Subject: Braidwood Station Unit 1
NRC Docket Number: 50-456

Response to Request for Additional Information Pertaining to Operating Interval
Between Eddy Current Inspections for Circumferential Indications in the
Braidwood Unit 1 Steam Generators

ATTACHMENT A
REQUEST FOR ADDITIONAL INFORMATION
RELATED TO THE BRAIDWOOD, UNIT 1 CYCLE LENGTH ASSESSMENT
BASED ON STEAM GENERATOR (SG) TUBE
CIRCUMFERENTIAL INDICATION GROWTH RATES
DOCKET NUMBER 50-456

Figure 19a. Voltage Normalization Regression Analysis for Maximum Voltage

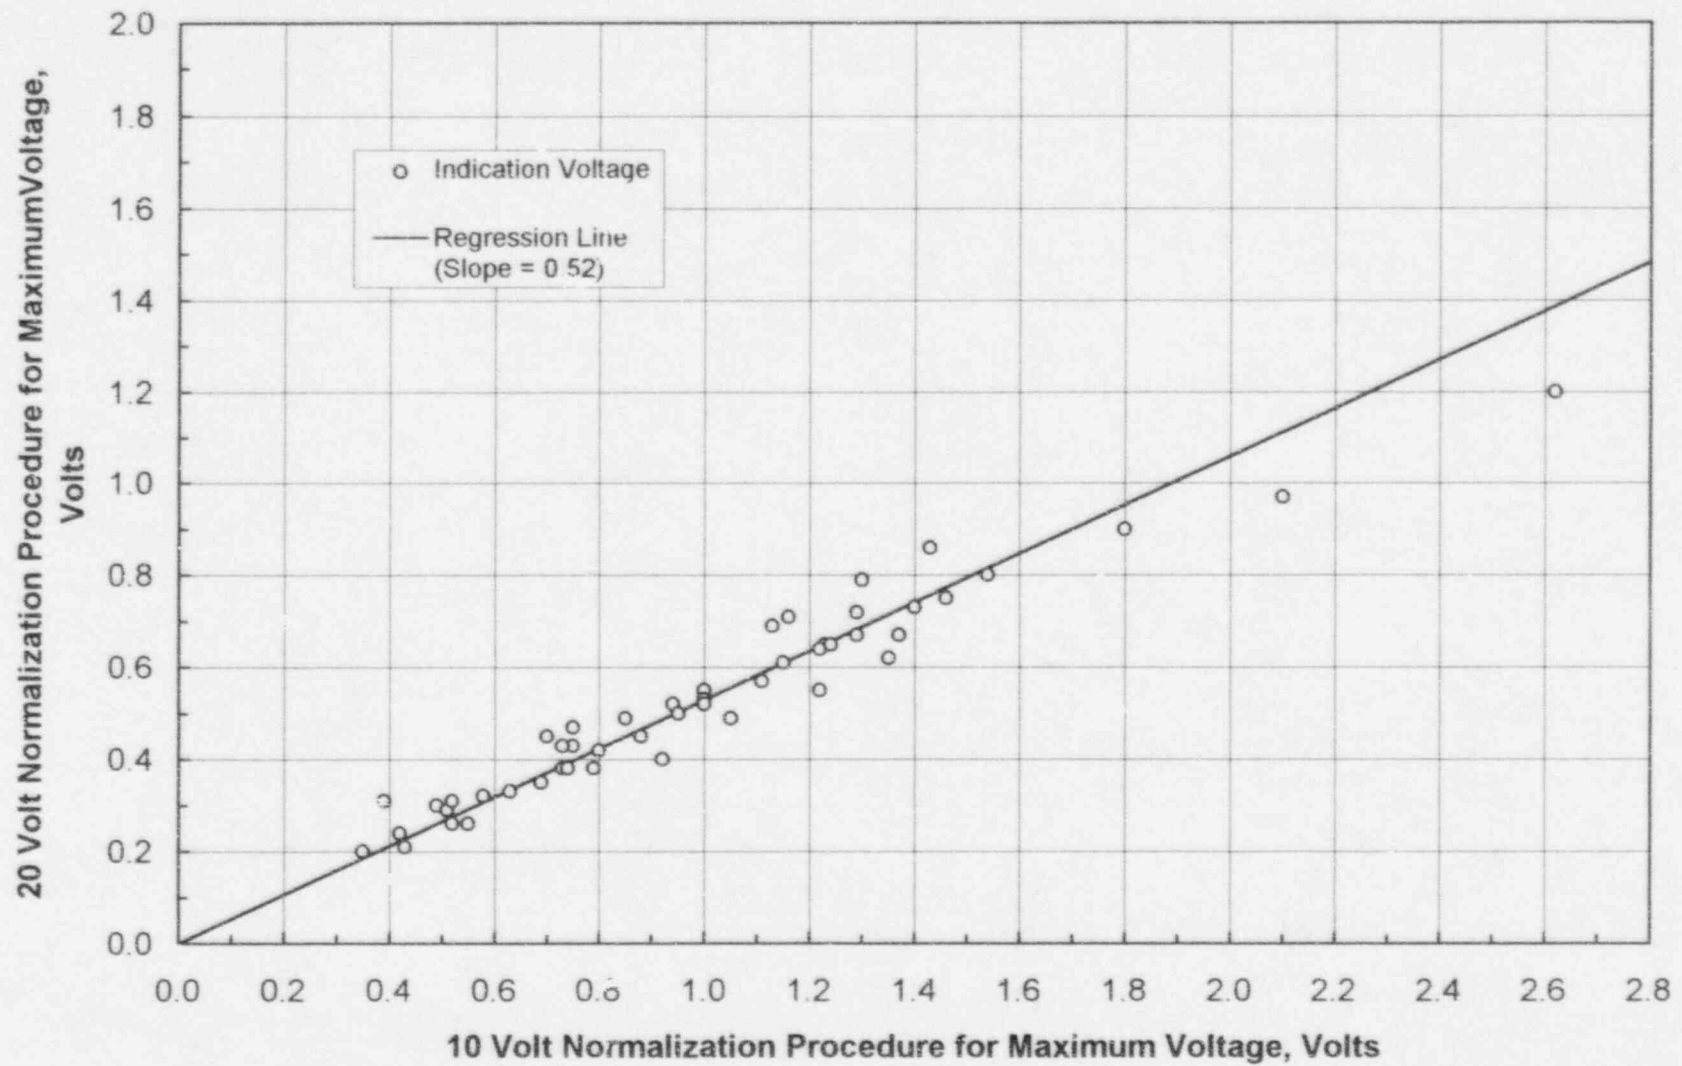
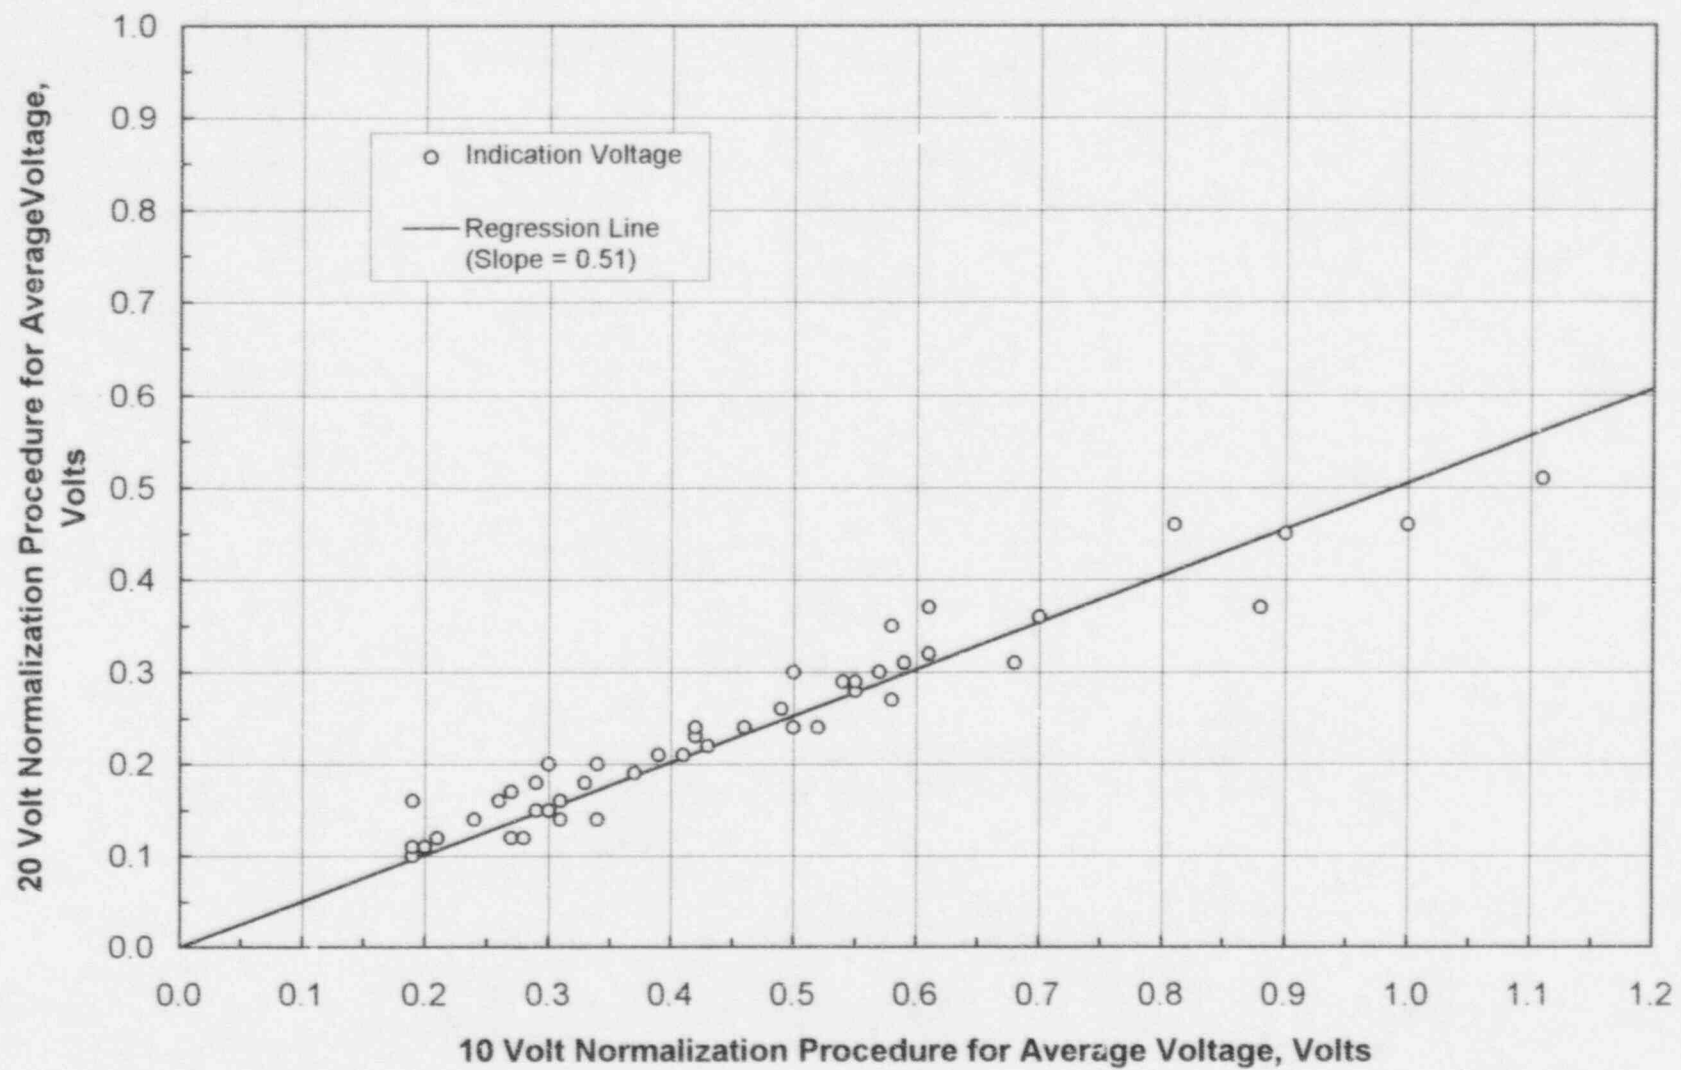
- 19. In Section 6.2.1 of the submittal dated August 2, 1996 the EC voltage normalization procedure for adjusting the SG tube burst and leakage data is described. This EC voltage adjustment was made to obtain consistent EC voltages for circumferential indications where the calibration standard did not contain an axial EDM notch. Discuss how the EC voltages for other reflectors in the calibration standard compare with the 0.58 correction factor applied to the data. Provide a statistical analysis based on field data which supports the use of the 0.58 correction factor.**

An evaluation of the application of the 0.58 normalization correction factor to other reflectors in the calibration standard has been performed. The results are shown in Table 19a. The table includes: the other reflectors included in the evaluation, the voltage normalized to 10 Volts on a 100% throughwall hole (TWH), the voltages normalized to 20 Volts on the 100% axial EDM notch and the ratio of the two voltages. The results indicate that the voltages normalized to 10 Volts on a 100% TWH and corrected with a 0.58 correction factor are consistent for the different reflectors included in the analysis.

Figure 20a. Coil Size Regression Analysis for Maximum Voltage

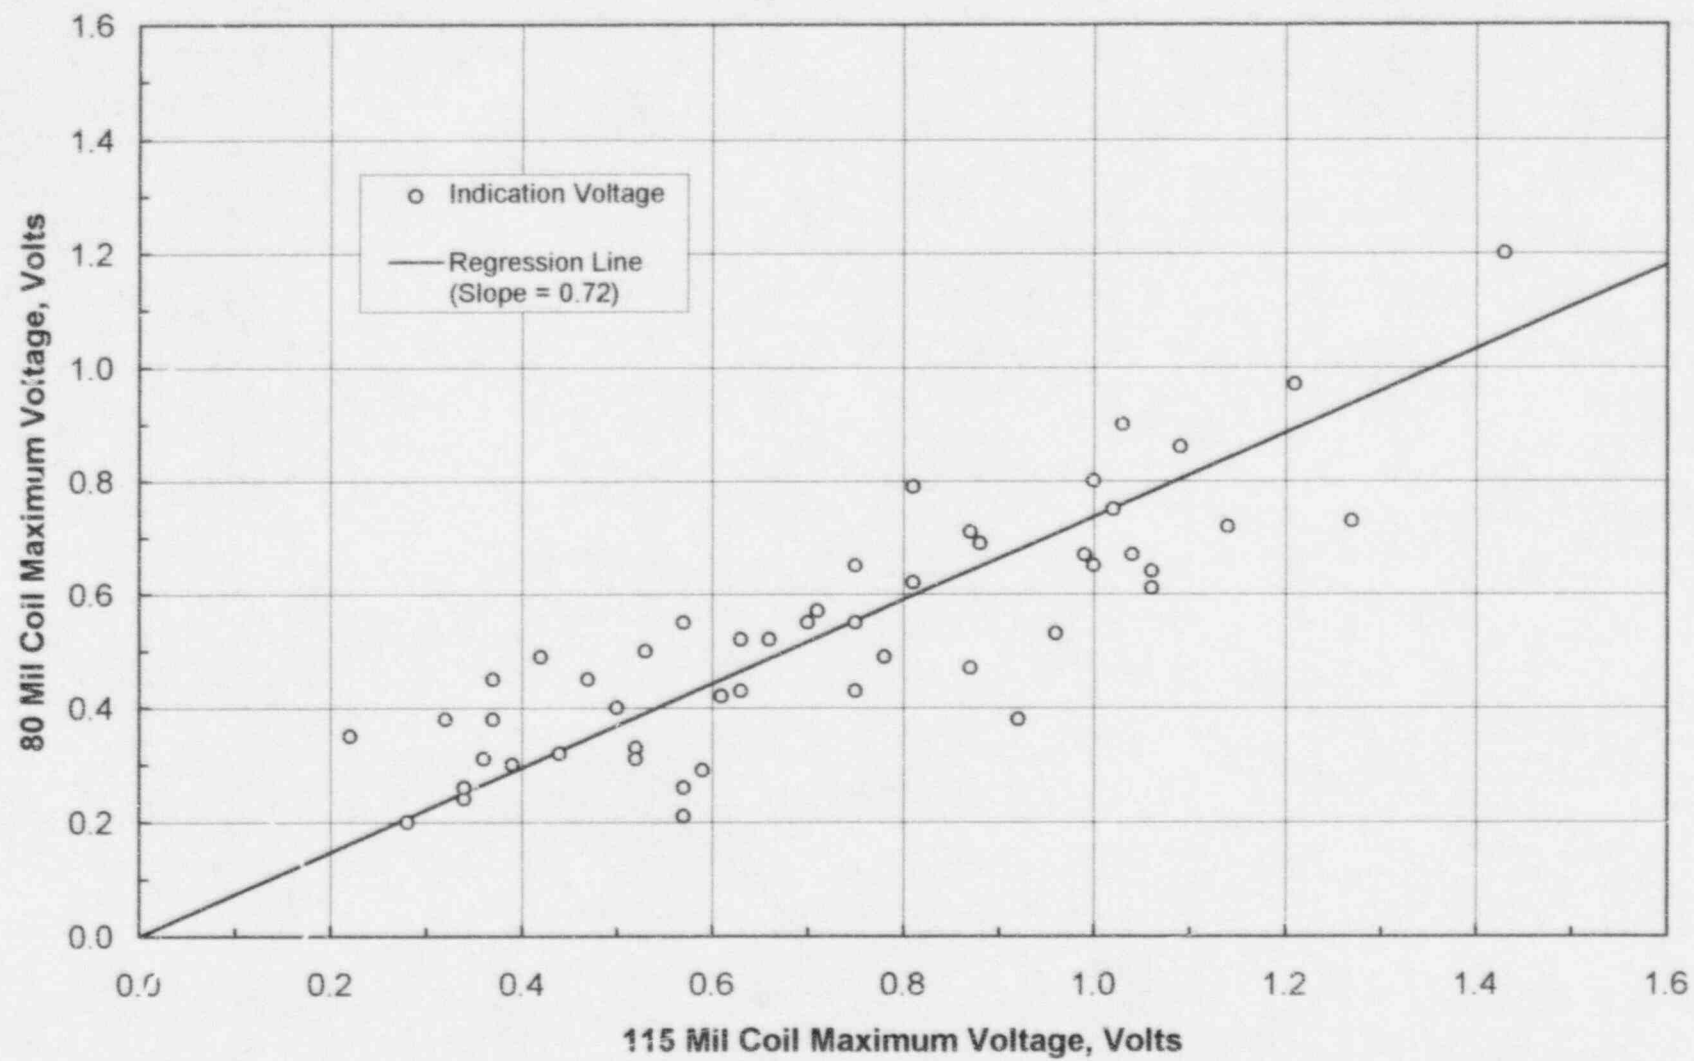
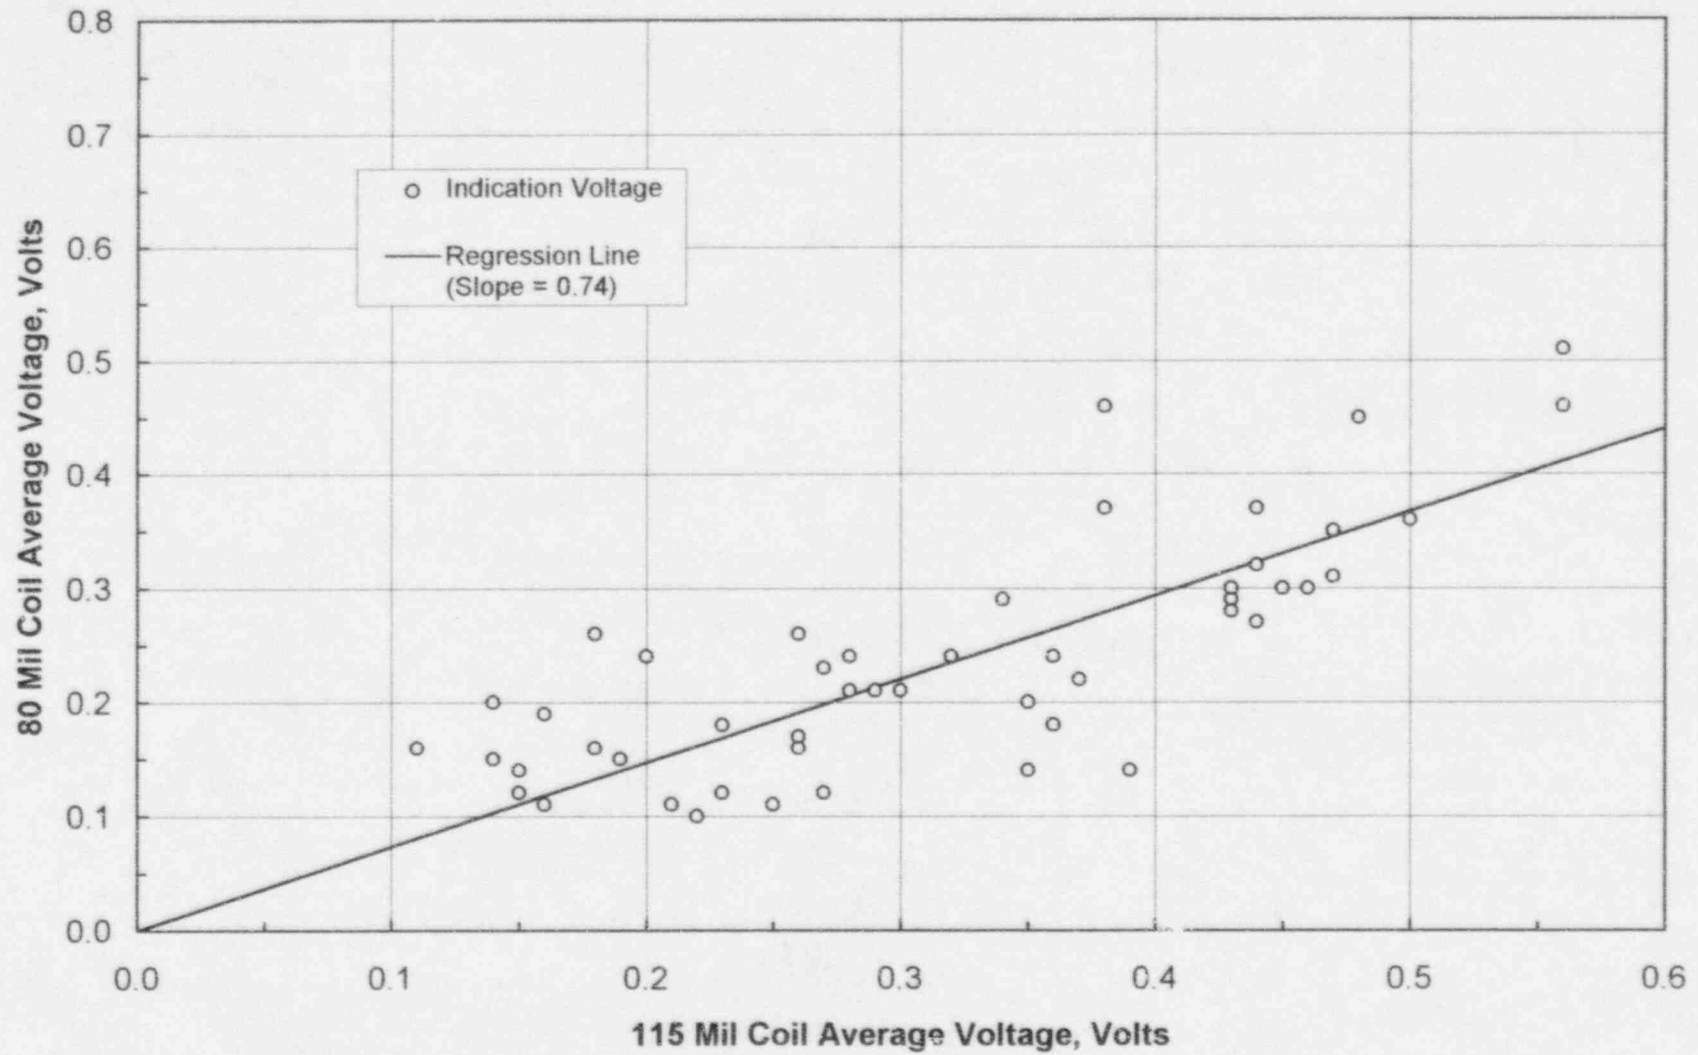
- 20. A 0.76 correction factor was applied to adjust 0.115-inch probe coil EC voltages to equivalent 0.080-inch probe coil EC voltages. Describe in detail the development of this correction factor, including a discussion on the number of samples reviewed, the types of defects analyzed, and the mean and standard deviation of the study sample. Additionally, provide the recorded EC voltages, if practical, or the range of circumferential indication EC voltages included in the sample. Provide a statistical analysis based on field data which supports the use of the 0.76 correction factor.**

During a look-back of three hundred and fifty 1996 Byron Unit 1 indications in SG C, analysis of the indications was performed using the 0.115" and 0.080" pancake coils. The look-back was performed prior to development of the voltage integral software. Because all the 0.080" RPC indications in one SG were included, a range of indication size (0.06 to 1.11 0.080" RPC Volts) is included in the data set. The average of the three hundred and fifty 0.080" RPC voltages (mean of 0.326 Volts and standard deviation of 0.204 Volts) was compared to the average of the 0.115" RPC voltages (mean 0.431 Volts and standard deviation of 0.269 Volts). From this result a scale factor for the 0.115" RPC is calculated from the ratio of the mean voltages, or $0.326/0.431 = 0.76$. This scale factor was applied to some of the insitu pressure test data included in the industry data base burst limits. The scale factor was not applied to any tube pull burst data points because the data was acquired with the 0.080" RPC. Many of the data points used in the leak rate assessment had the scale factor applied since much of the data was obtained from 0.115" RPC.
